VERMONT	
ACT 250 District Commission	# 7
Application #: 7C0627-2	
Exhibit #: 027	
Date Received: 9/11/25

7C0627-2 Louis Buzzi - ANR Rivers Program Rebuttal Comments regarding Act 250
Criterion 1(D) Flood hazard areas; river corridors

Following the Commission's July 28, 2025 Recess Memo and the Applicant's August 25, 2025 response, the Agency of Natural Resources Rivers Program provides the following comments.

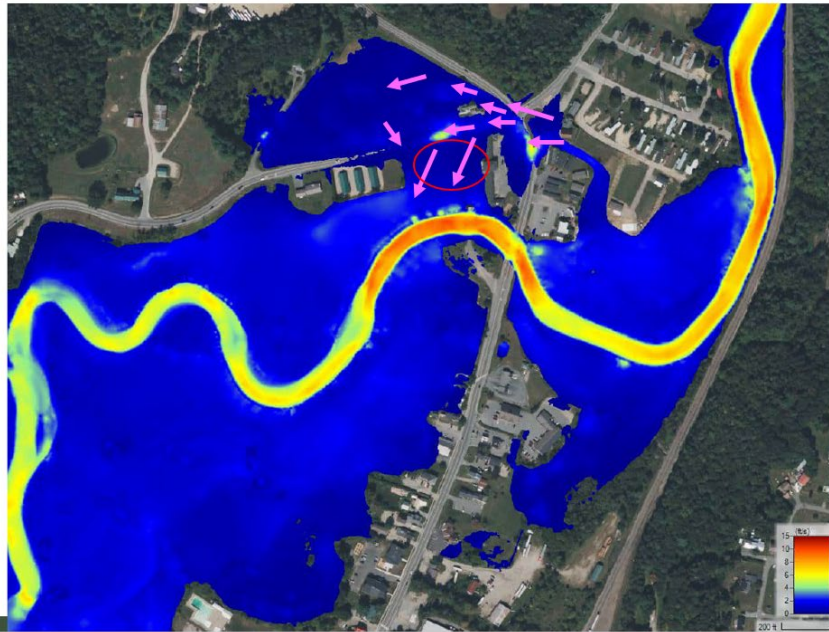
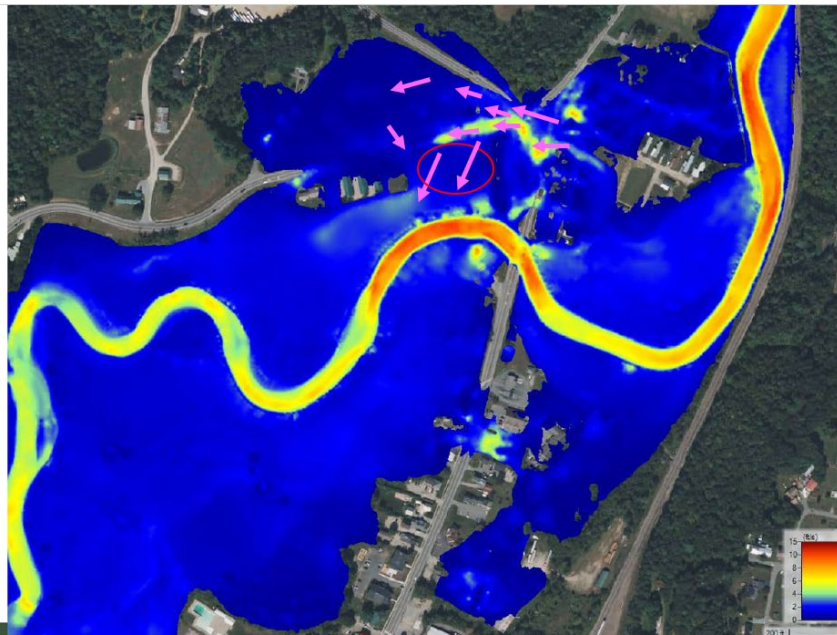
Raising the site will affect how floodwater flows in this location. If the northern or central part of the parcel was simply storing floodwater like a pond, as characterized in the filed application and in testimony at the hearing, rather than conveying or allowing for water to flow through the parcel, then there would be less concern about the potential impacts of restricting or diverting floodwaters. However, the Final Report for the SLR Flood Study, dated 1/3/2025 (attached), shows that this portion of the floodplain is hydraulically connected and conveying floodwater across VT Route 122 during the SLR modeled 50-year, 100-year and 500-year flood event (see SLR Study Appendix A Existing Conditions). Flood depth maps in the report (pgs. 24-26) show how floodwater partially bypasses the Route 5 bridge, crosses Route 5 and VT Route 122, and reconnects to the river through the project parcel in the area that is proposed to be filled.

Additionally, when we look at the flood velocities for the SLR modeled 50-year, 100-year, and 500-year flood events (pgs. 28-30 of the SLR Study, and Figure 1 below), we see that the area around the subject parcel does experience higher-velocity flood flows as water is conveyed across Route 5 and VT Route 122, through the parcel, and back to the much more expansive Passumpsic River floodplain downstream.

- 1) *Flood depths behind (upstream of) the fill would be expected to become deeper.*
The SLR Study shows that the entire portion of the parcel located west of the former Lynburke Motel site is conveying water during the SLR-modeled 50-year, 100-year, and 500-year flood events. If the parcel is filled as proposed, the remaining available area to convey floodwater across VT Route 122 will be significantly smaller and likely convey a smaller volume of water. This will likely result in backing up floodwater behind this new pinch point. This is similar to an undersized culvert that pools or backwaters.

- 2) *Floodwater velocities are expected to increase through the more confined channel still able to convey floodwater.* This is similar to placing your finger over the end of a hose – reducing the available area for water to pass results in the water moving faster. We would anticipate that this may result in greater rates of erosion and scour during flooding along the northern and western property boundary where the water would be channeled.

The accepted engineering standard to resolve these concerns is to use hydraulic modelling of the specific proposed design and show no impact to flood heights or velocities. This would demonstrate whether the project would present a particular flood risk to adjacent landowners and residents.

To demonstrate that the project will have No Adverse Impact (NAI) on neighboring properties, modelling is needed to show no more than 0.1 foot (or 1.2”) rise in flood heights and no more than 0.3 feet per second increase in flood velocities during the base flood. These are measurable amounts of impact that can be determined through hydraulic modeling. The use of hydraulic modeling has been the standard engineering practice for assessing impacts from landscape change during flood events for more than 50 years – at least since the creation of the National Flood Insurance Program (NFIP) in 1968. It is the basis for the NFIP’s flood hazard mapping program and part of the process that FEMA uses to assess impacts and require changes to the Flood Insurance Rate Maps (FIRMs). Testimony at the hearing and in the response letters did not provide enough analysis to avoid the need for modeling.
